NSW REZ access standards intended to apply to Central-West Orana REZ: consultation package

The CEC welcomes the opportunity to comment on the NSW Department of Planning, Industry and Environment's (DPIE, the Department) Consultation Paper on the Central West Orana (CWO) Renewable Energy Zone (REZ) draft Access Standards as part of the Electricity Infrastructure Roadmap.

Figure 1 Connection Point SCR vs Terminal SCR for two Generating System Sizes (cable impedances excluded for simplicity)

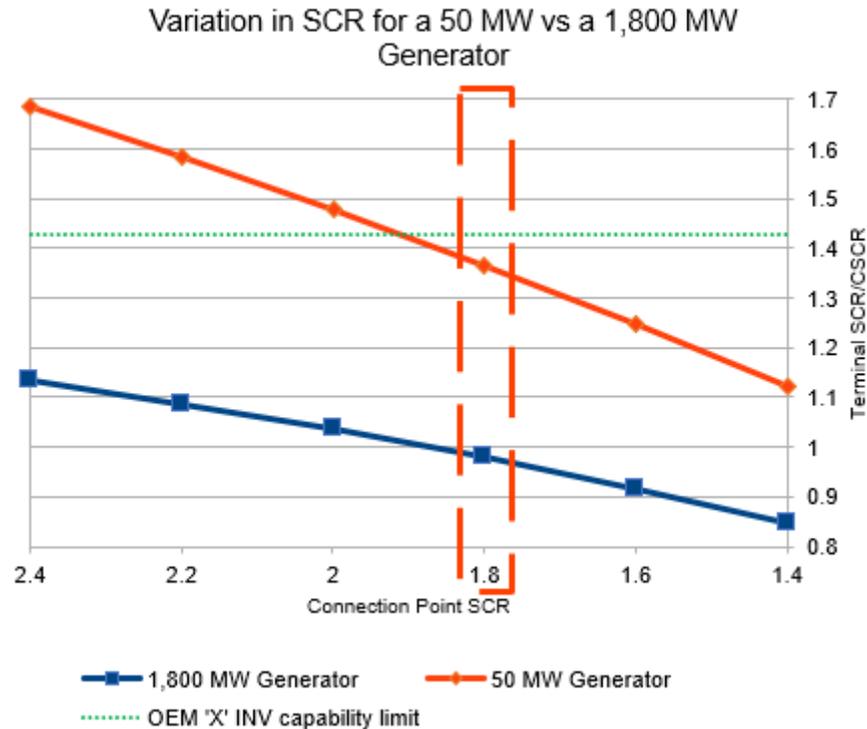
No.	Item	Comment	Recommendation
1	SCR of 1.8 at POC translates to a lower SCR at the terminals	<ol style="list-style-type: none"> 1. An SCR of 1.8 at the POC equates to less than 1.4 at the terminals for projects as small as 50 MW (refer Figure 1 below)². 2. An SCR of less than 1.4 is lower than what some OEM's have demonstrated stable operation for (both in terms of modelling and actual project experience). 	Apply the 1.8 SCR requirement at the Generating Unit terminals.
2	A SCR of 1.8 at the POC would be a disincentive for larger projects	<ol style="list-style-type: none"> 1. Although larger projects generally result in lower overall LCOE, the higher balance of plant impedance will result in a lower terminal SCR below the capability of the technology. Hence be a disincentive to larger projects. 2. The SCR at the terminals for very large projects could be less than 1 (refer Figure 1 below). 	Apply the 1.8 SCR requirement at the Generating Unit terminals.

Power system impacts	<i>The need for meeting the SCR of 1.8 at the connection point should be compared with the lowest expected SCR within the CWO REZ. Any future reductions in network fault levels are outside the reasonable control of connecting generators and should be managed through a power system planning process.</i>
Technical plant impacts	<i>Larger Generating Systems with a large balance of plant impedance would result in a SCR at the Generating Unit terminals below the equipment capability (and in some cases below 1).</i>
